VTM COMPLIANCE EXHIBITS
 TITLE PAGE
 MIRAMONTE
 SOLEDAD, CALIFORNIA
 APRIL, 2021

VTM COMPLIANCE EXHIBITS
KEY MAP
MIRAMONTE
SOLEDAD, CALIFORNIA
APRIL, 2021

AREAS 3 & 4

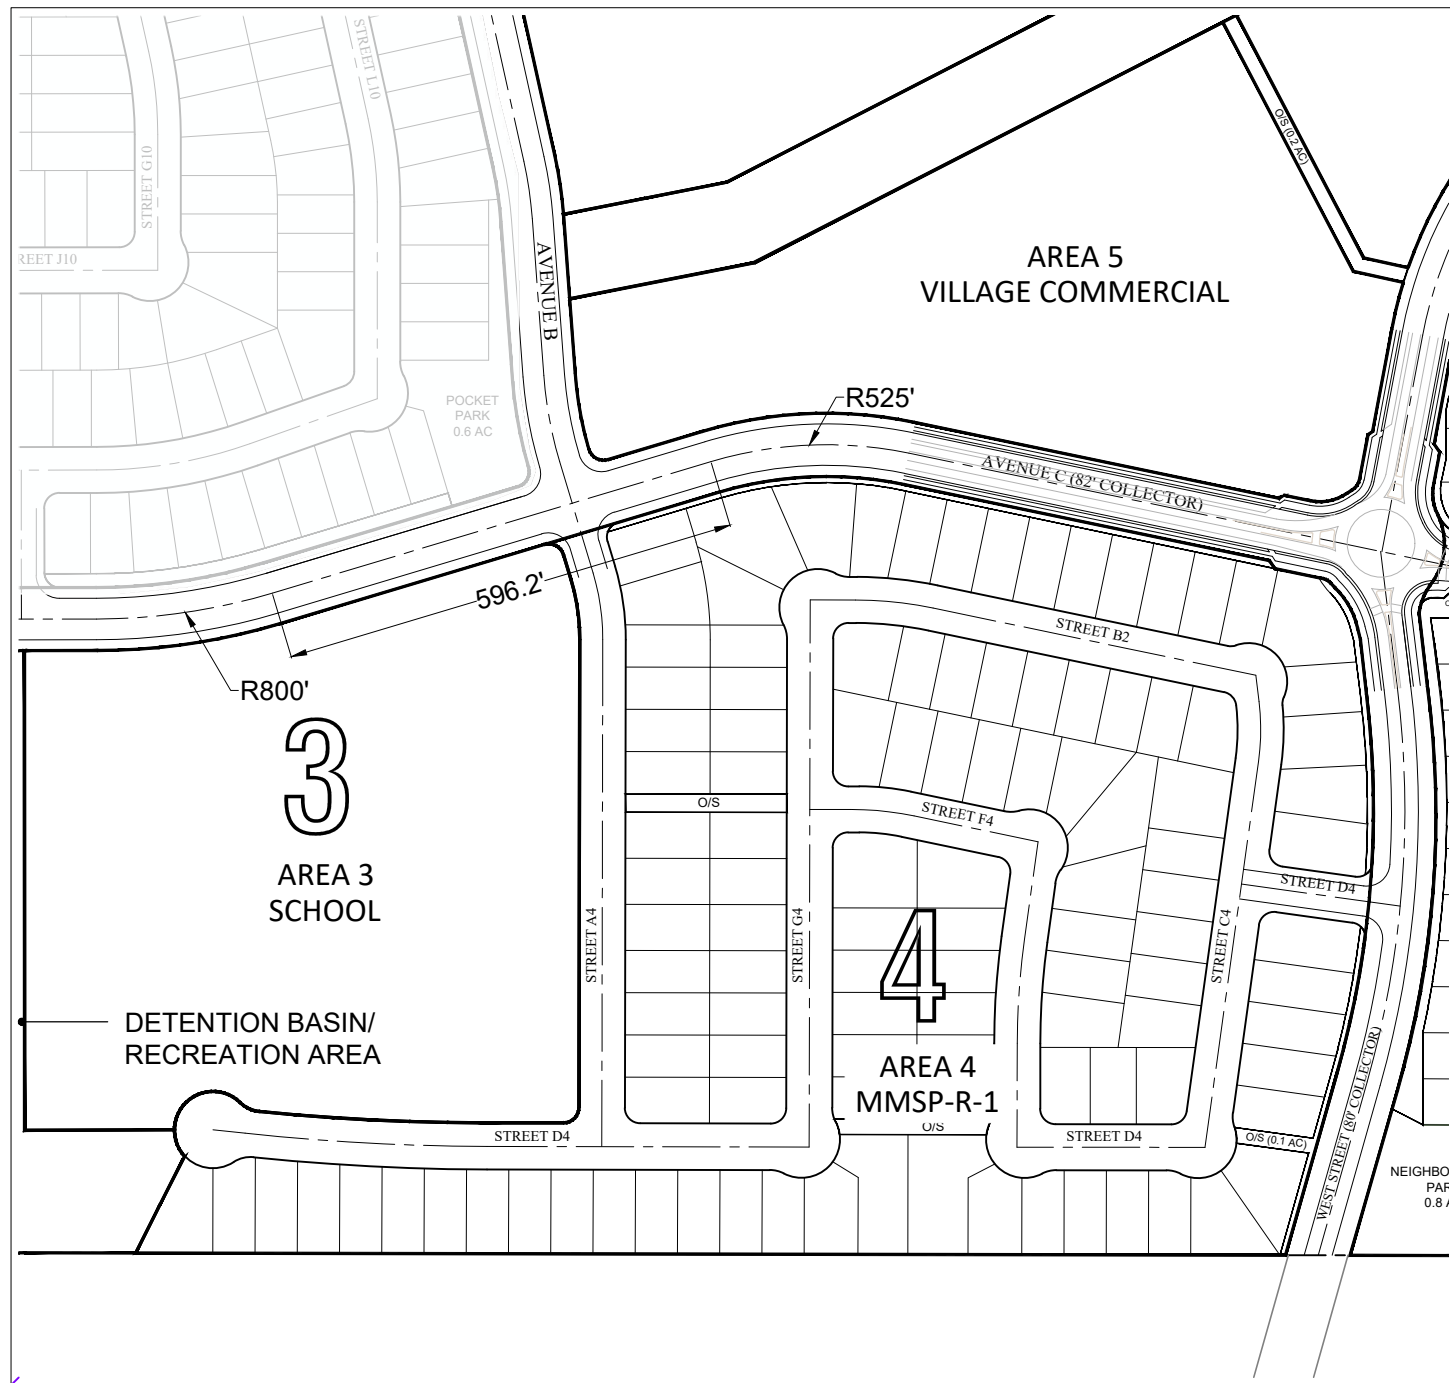
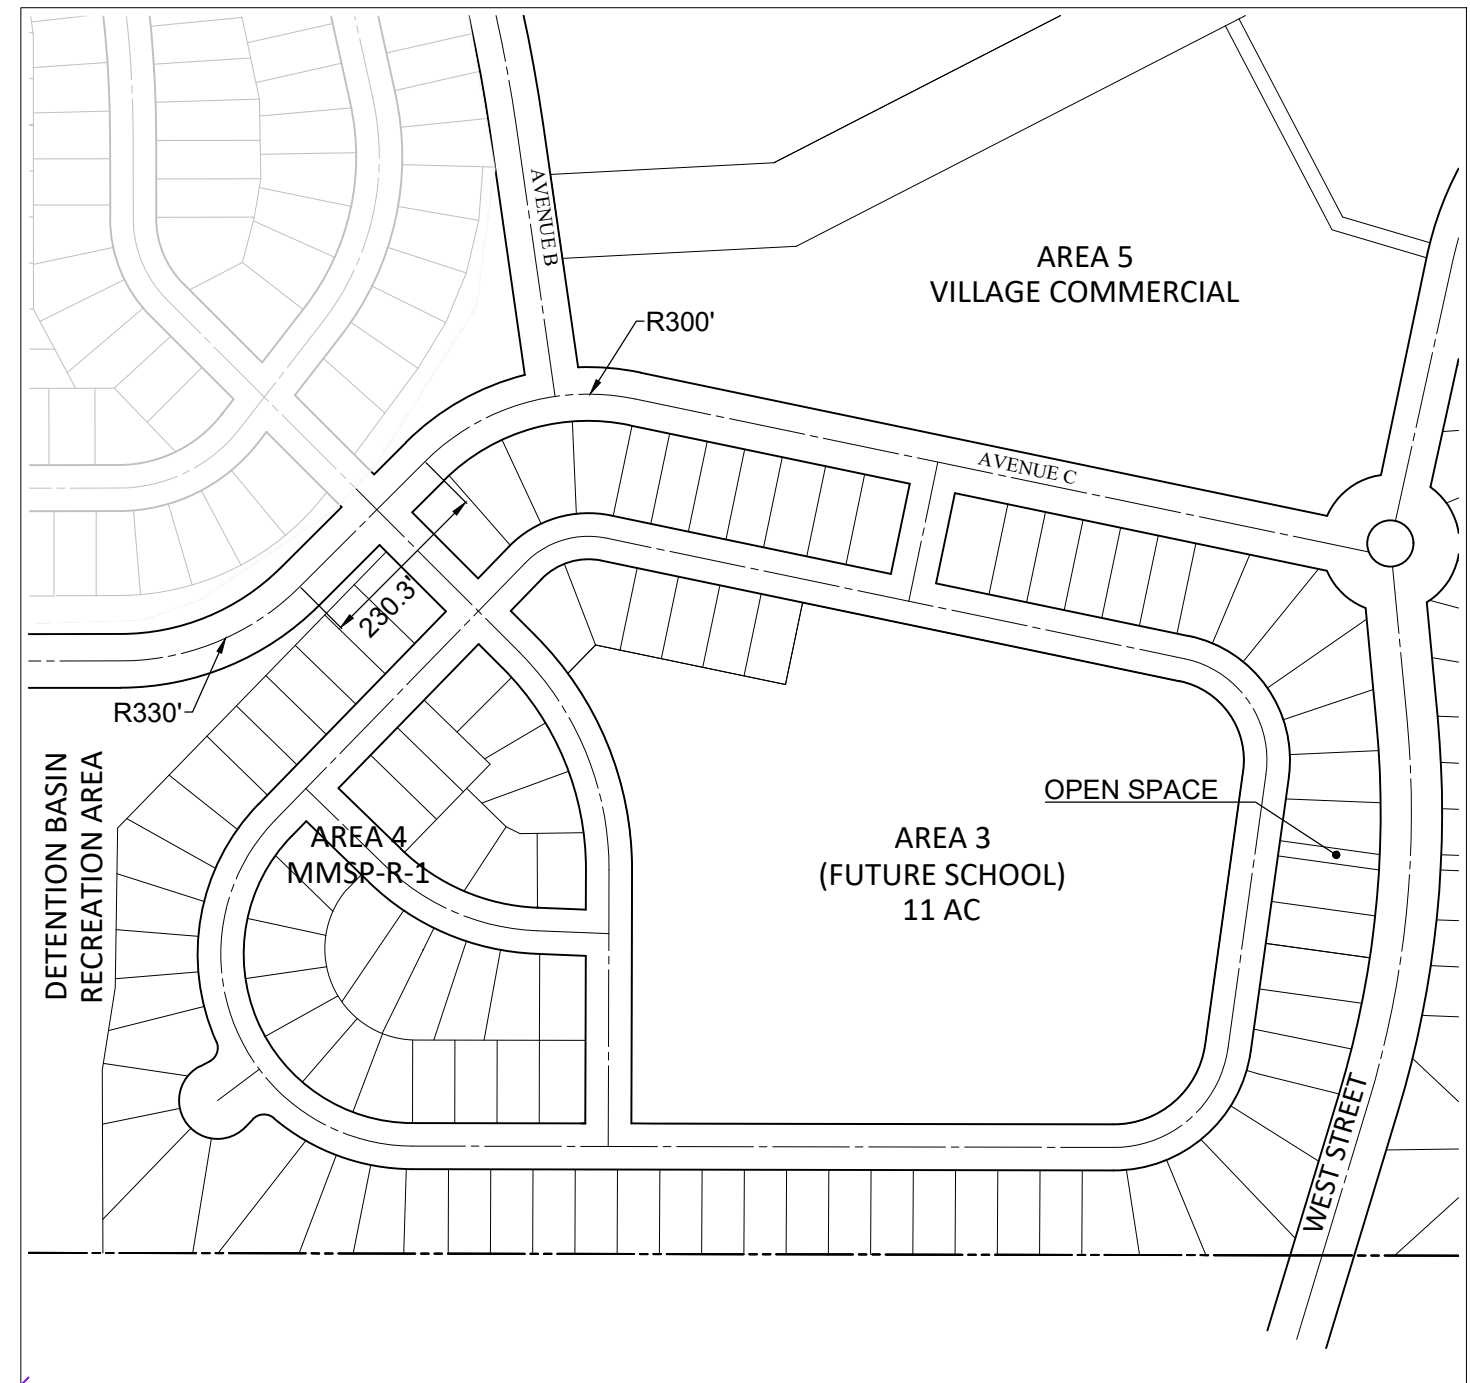
1. SCHOOL SITE - AREA 3
 - a. MOVED TO BE ADJACENT TO THE BASIN PARK
 - b. OPENS THE VIEWS FROM AVENUE C ALONG THE PROJECT ENTRY
 - c. AVOIDS RESIDENTIAL LOT BACKING ONTO THE SCHOOL SITE
 - d. LESS CONFLICT WITH ADJACENT RESIDENTIAL TRAFFIC
2. RESIDENTIAL NEIGHBORHOOD - AREA 4
 - a. MORE COHESIVE NEIGHBORHOOD DUE TO SCHOOL RELOCATION
 - b. ELIMINATES THE LOTS BACKING ONTO THE BASIN PARK
 - c. REDUCES THE NUMBER OF LOTS FRONTING THE SCHOOL, THUS REDUCING TRAFFIC CONFLICTS
3. INCREASED THE ROW FOR AVENUE C AND WEST STREET TO ACCOMMODATE THE TWO-WAY LEFT-TURN LANE RECOMMENDED BY THE CITY'S TRAFFIC CONSULTANT
4. INCREASED THE CENTERLINE RADII OF AVENUE C FOR REASONABLE DESIGN SPEED

VTM COMPLIANCE EXHIBITS
 AREA 1 & 2
 MIRAMONTE
 SOLEDAD, CALIFORNIA
 APRIL, 2021

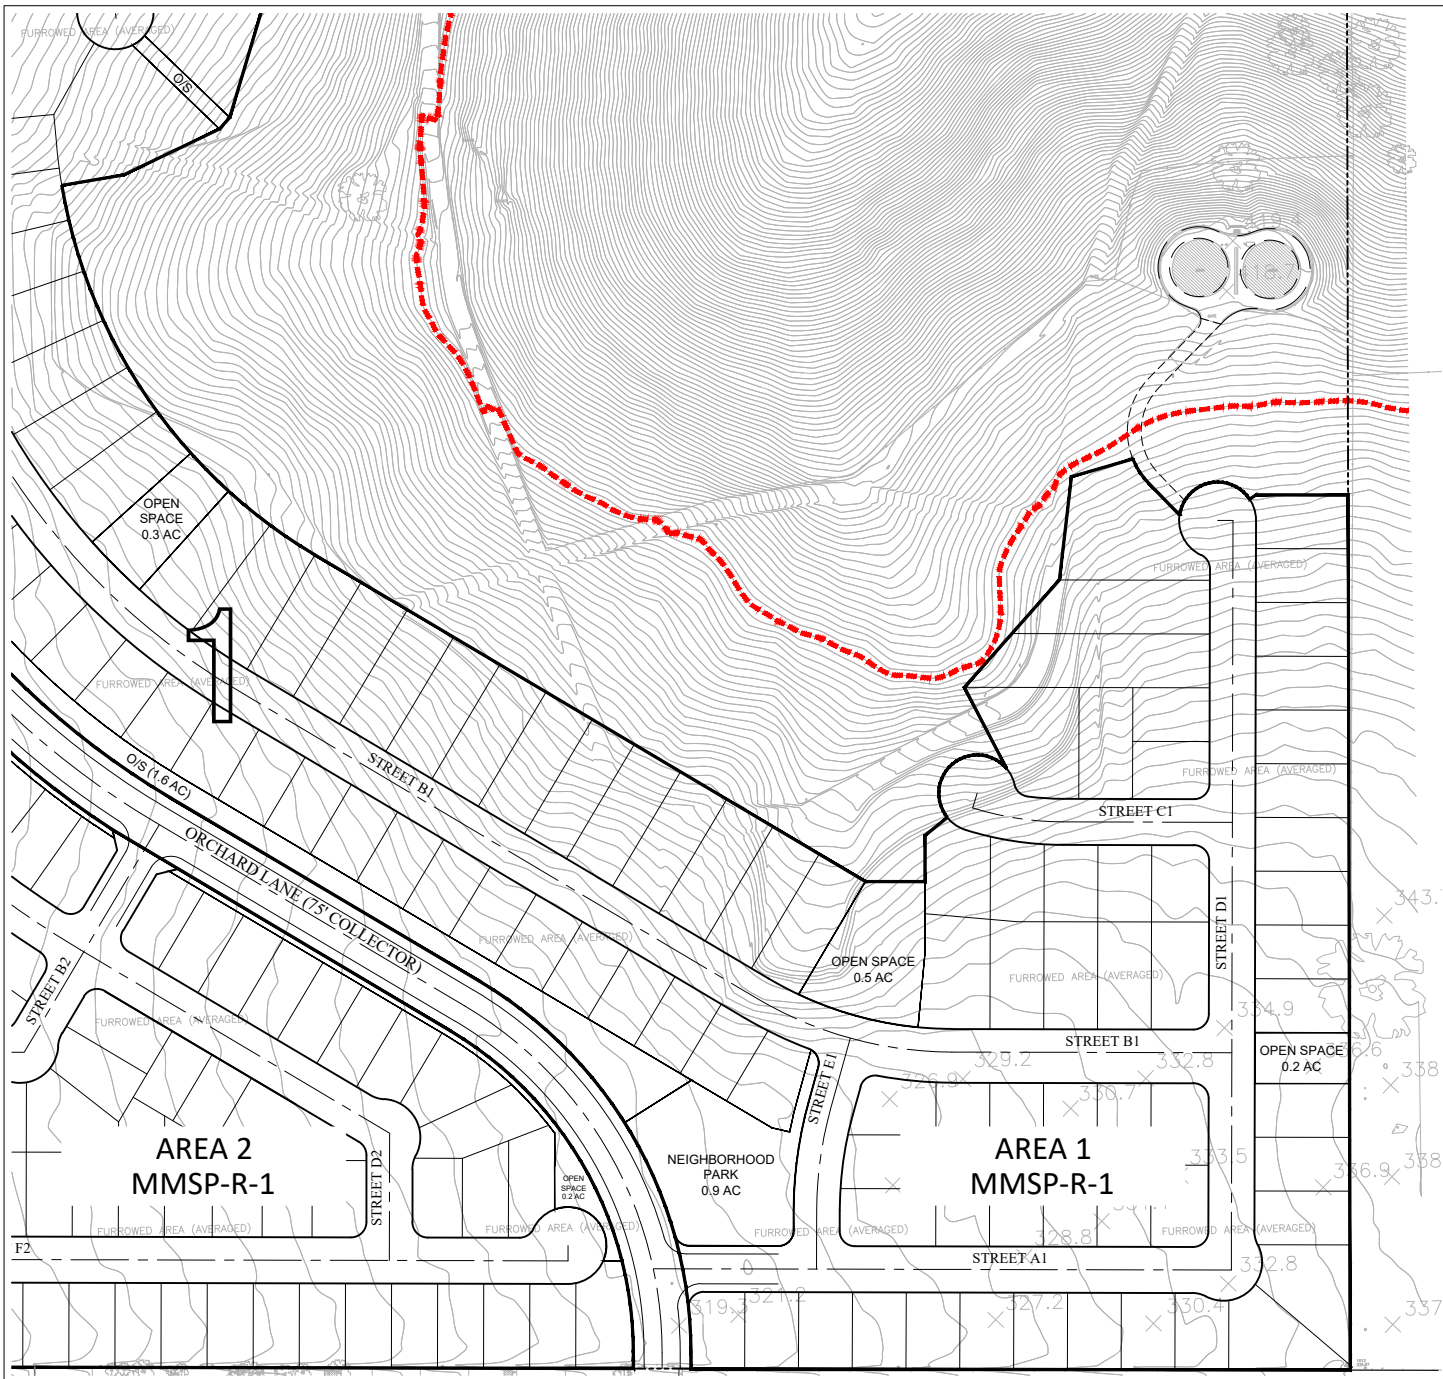
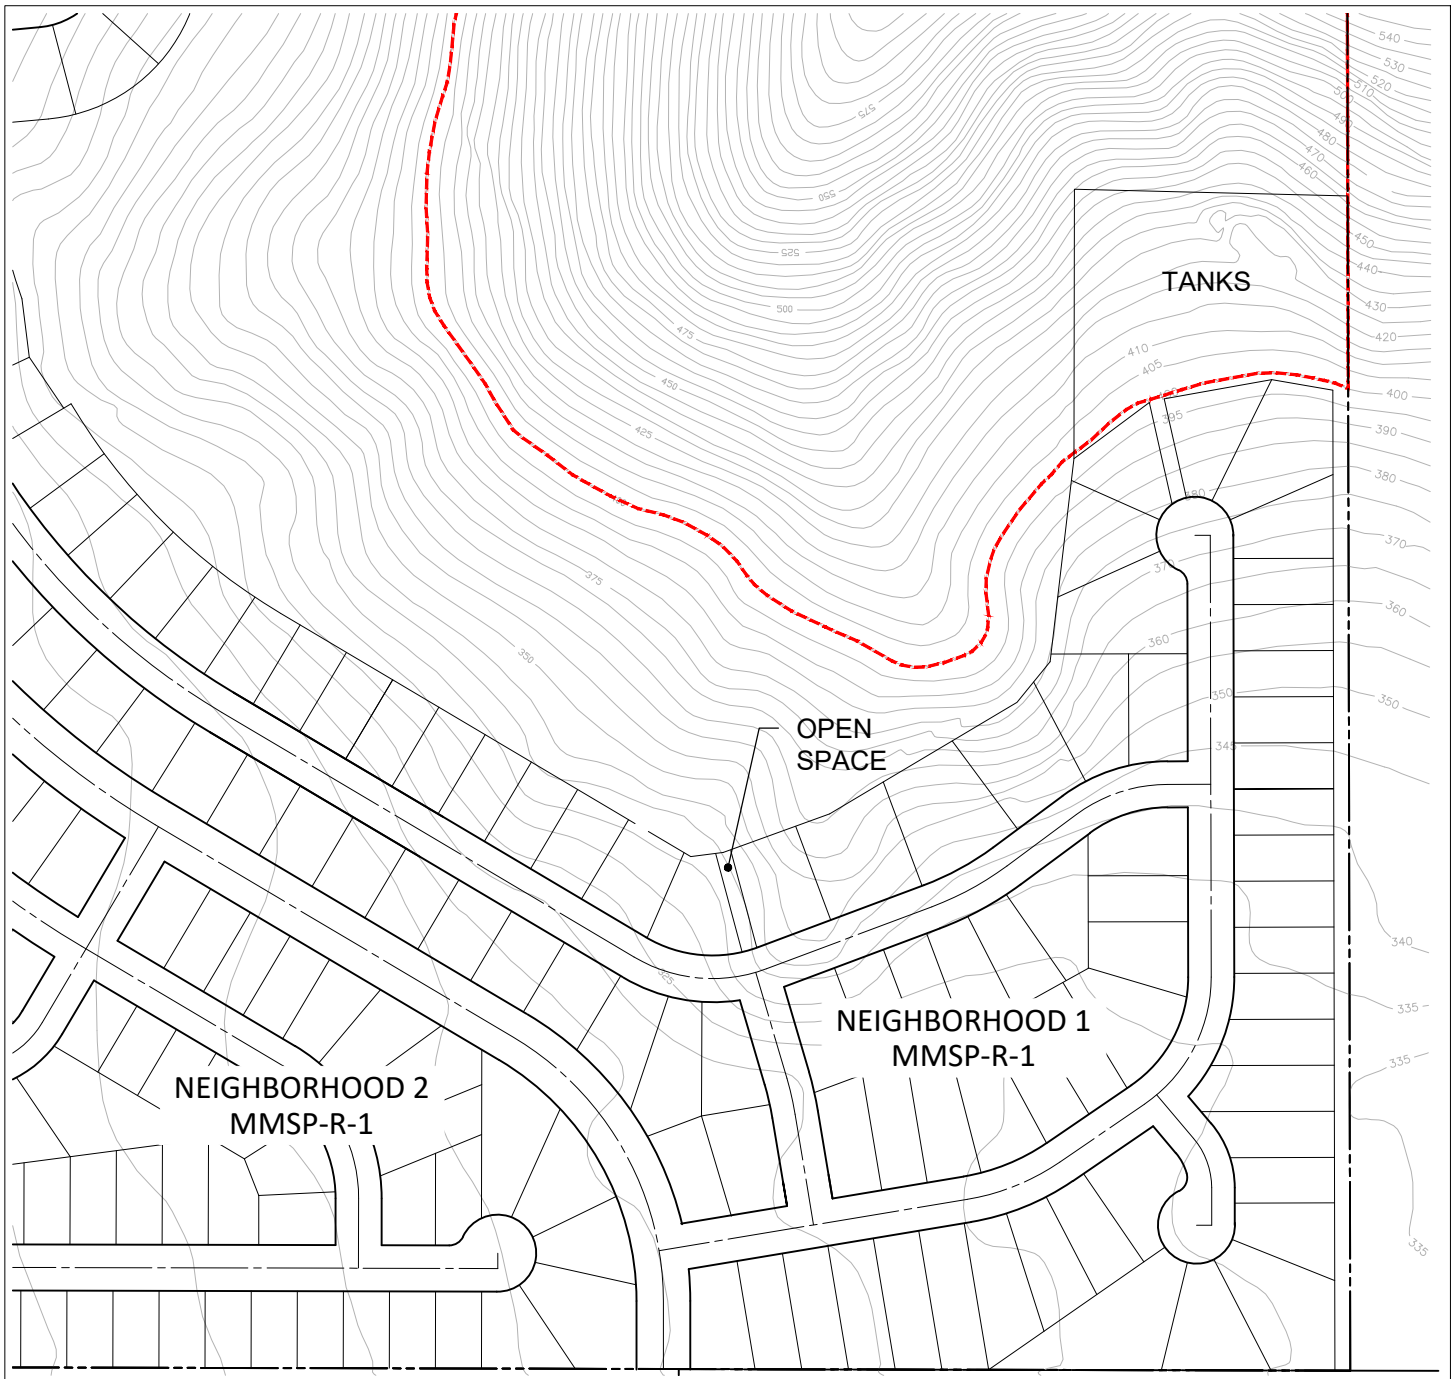
- 1. RESIDENTIAL NEIGHBORHOOD - AREA 1:
 - a. OPEN SPACE ADDED ALONG THE EASTERLY BOUNDARY TO ALLOW EMERGENCY OVERLAND FLOW FROM A LARGE OFFSITE DRAINAGE AREA
 - b. OPEN SPACE ADDED ALONG ORCHARD LANE TO ACCOMMODATE GRADE CHANGES AND FOR PUE AREA
 - c. MINOR STREET ALIGNMENT CHANGES
 - d. ADDED 0.9 ACRES NEIGHBORHOOD PARK
 - e. INCREASED THE CENTERLINE RADII OF ORCHARD LANE FOR REASONABLE DESIGN SPEED
 - f. LOTS BACKING ONTO THE HILLSIDE OPEN SPACE ARE DEEPENER TO ACCOMMODATE THE REQUIRED CONFORM SLOPE
- 2. RESIDENTIAL NEIGHBORHOOD - AREA 2
 - a. OPEN SPACE ADDED ALONG ORCHARD LANE FOR PUE AREA
